APPLICATION NO.	FILING DATE	FIRST NAMED INVENTOR	ATTORNEY DOCKET NO.	CONFIRMATION NO.
10/065,091	09/17/2002	Fang-Chen Luo	5486-US-PA	4158

Office Action Summary	Application No. 10/065,091	Applicant(s) LUO ET AL.	
	Examiner TIMOTHY RUDE	Art Unit 2871

DETAILED ACTION

FIG. 1

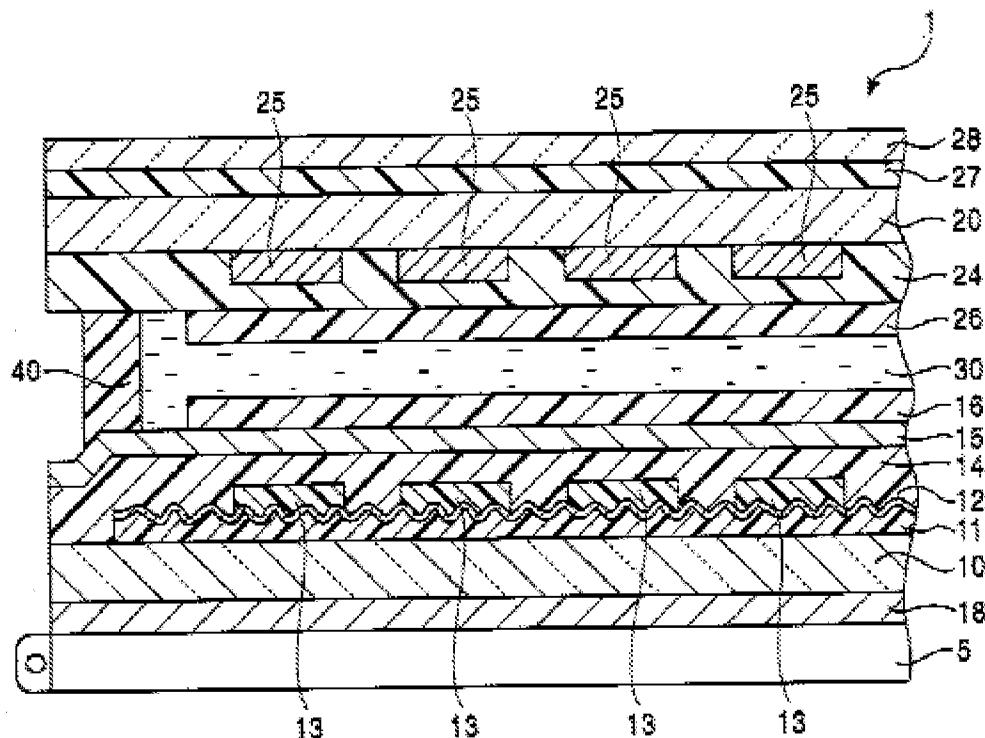
As to claims 56-58, 62, 63, 65, and 67, Tanada discloses and shows in Fig. 1, a liquid crystal display (LCD) structure comprising a first substrate panel (10) made of glass, a second substrate panel and a liquid crystal layer (30) disposed between the first substrate panel and the second substrate panel, a plurality of pixel portions being formed by respective electrodes for applying a voltage to the liquid crystal layer, each of the pixel portions comprising:

an organic insulating layer (11) such as photosensitive resin solution, such as acrylic resin (page 3, [0046]) over the first substrate panel (1), wherein the surface of the organic insulating layer has a plurality of protrude/recess structures thereon;

a conformal reflective layer (12) over the organic insulating layer (11), wherein the conformal reflective layer serves as a reflector of light;

a transparent dielectric layer (13 and 14) (color filters with their overcoat layer) over the conformal reflective layer (12), wherein the dielectric layer is a color filter layer (comprising overcoat layer) that has a substantially planar surface (smoother upper surface than the bumpy organic insulating layer); and

a first transparent conductive layer (15) conformably over the transparent dielectric layer (13 comprising 14) which is the color filter layer (comprising overcoat layer), wherein the conformal reflective layer (12) is electrically isolated from the first transparent conductive layer (15).

wherein (Fig. 1) the LCD structure further includes a second transparent conductive layer (25) over the second substrate panel (20) and the liquid crystal layer (30) between the second transparent conductive layer and the first transparent conductive layer.

Tanada does not explicitly disclose that the first conductive layer is connected to the TFT for controlling the liquid crystal layer.

Regarding newly added limitations, the color filter layer comprising overcoat layer of Tanada does completely cover the conformal reflective layer.

As to claim 66, Tanada also shows in Fig. 1 that the surface of the second substrate panel on the opposite side of the liquid crystal layer further includes a phase compensation plate (27) and a polarizer (28).

FIG. 13

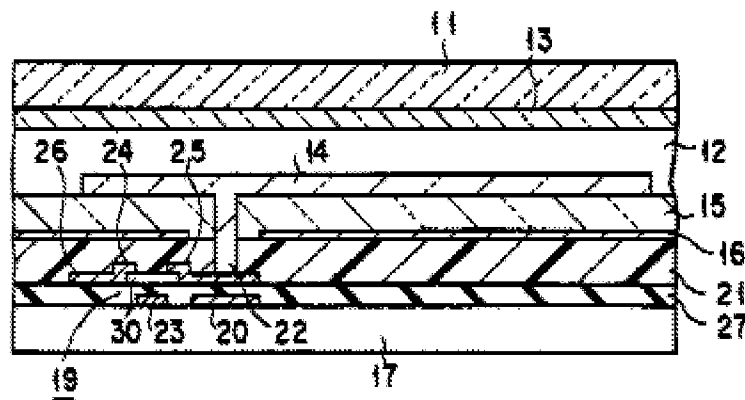
Nakai discloses an LCD device (Fig. 13) having a first conductive layer (14) connected to the TFT (19) through the contact hole (22) and source electrode (25) for controlling the liquid crystal layer.

Nakai is evidence that workers of ordinary skill in the art would find the reason, suggestion, or motivation to add a first conductive layer (14) connected to the TFT (19) through the contact hole (22) and source electrode (25) for controlling the liquid crystal layer in order to provide a high efficiency of light utilization (col. 14, lines 59-60) in the control of the liquid crystals in addition to improved whitening, power savings due to a reduced resistance, and higher speed of operation (col. 4, lines 61-67). Ultimately, this not only provides improved picture quality (col. 4, lines 65-66), but also provides a display device that is more easily controlled and is more stable for optimal performance (col. 2, lines 14-17).

Therefore, it would have been obvious to one having ordinary skill in the art at the time the invention was made to modify the invention of Tanada with the first conductive layer (14) connected to the TFT (19) through the contact hole (22) and source electrode (25) for controlling the liquid crystal layer in order to provide a high efficiency of light utilization (col. 14, lines 59-60) in the control of the liquid crystals in addition to improved whitening, power savings due to a reduced resistance, and higher speed of operation (col. 4, lines 61-67) with improved picture quality (col. 4, lines 65-66), resulting in a display device that is more easily controlled and is more stable for optimal performance (col. 2, lines 14-17).

Please note, as combined above, the resulting reflective layer covers the second terminal of the TFT, but it exposes the first terminal of the TFT to the color filter via the contact hole. Examiner considers this to read on Applicant's "... first terminal of the thin film transistor is configured in the planar color filter layer while a second terminal of the thin film transistor is configured in the organic insulating layer." (see latter part of Applicant's claim 67).

FIG. 8

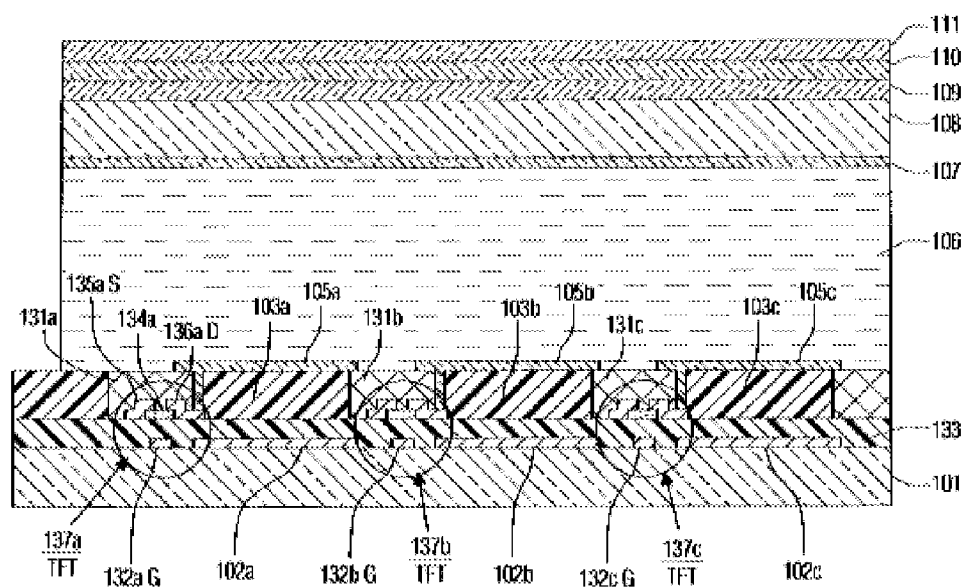
Ogawa teaches 1) a display having color filters that do not comprise an overcoat layer as an art recognized color filter suitable for the purposes of producing a color display [MPEP 2144.07], wherein the color filter layer fully covers underlying layers.

Ogawa is evidence that workers of ordinary skill in the art would find the reason, suggestion, or motivation to add color filters that do not comprise an overcoat layer as an art recognized color filter suitable for the purposes of producing a color display [MPEP 2144.07]. Please note that this proves the overcoat layer of Tanada was known to be NOT essential to such a reflective color filter display, which makes it obvious that the overcoat layer is optional.

Therefore, it would have been obvious to one having ordinary skill in the art at the time the invention was made to modify the invention of Tanada with color filters that do not comprise an overcoat layer and fully cover underlying layers as an art recognized color filter suitable for the purposes of producing a color display [MPEP 2144.07].

(2) It is respectfully pointed out that the color filter layer of Ogawa is contiguous (though multi-colored, as is Applicant's layer) and it does fully cover all underlying layers, including the conformal reflective layer(s).

F I G. 13

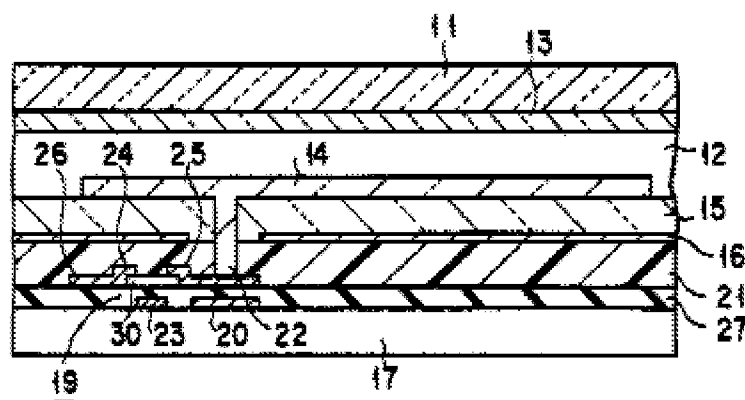
Nakai teaches 2) an LCD device (Fig. 13) having a first conductive layer (14) connected to the TFT (19) through the contact hole (22, goes through all intervening layers) and source electrode (25) for controlling the liquid crystal layer.

Nakai is evidence that workers of ordinary skill in the art would find the reason, suggestion, or motivation to add a first conductive layer (14) connected to the TFT (19) through the contact hole (22) and source electrode (25) for controlling the liquid crystal layer in order to provide a high efficiency of light utilization (col. 14, lines 59-60) in the control of the liquid crystals in addition to improved whitening, power savings due to a reduced resistance, and higher speed of operation (col. 4, lines 61-67). Ultimately, this not only provides improved picture quality (col. 4, lines 65-66), but also provides a display device that is more easily controlled and is more stable for optimal performance (col. 2, lines 14-17).

Therefore, it would have been obvious to one having ordinary skill in the art at the time the invention was made to modify the invention of Tanada with the first conductive layer (14) connected to the TFT (19) through the contact hole (22) and source electrode (25) for controlling the liquid crystal layer in order to provide a high efficiency of light utilization (col. 14, lines 59-60) in the control of the liquid crystals in addition to improved whitening, power savings due to a reduced resistance, and higher speed of operation (col. 4, lines 61-67) with improved picture quality (col. 4, lines 65-66), resulting in a display device that is more easily controlled and is more stable for optimal performance (col. 2, lines 14-17).

Please note, as combined above, the resulting reflective layer covers the second terminal of the TFT, but it exposes the first terminal of the TFT to the color filter via the

contact hole. Examiner considers this to read on Applicant's "... first terminal of the thin film transistor is configured in the planar color filter layer while a second terminal of the thin film transistor is configured in the organic insulating layer." (see latter part of Applicant's claim 67).
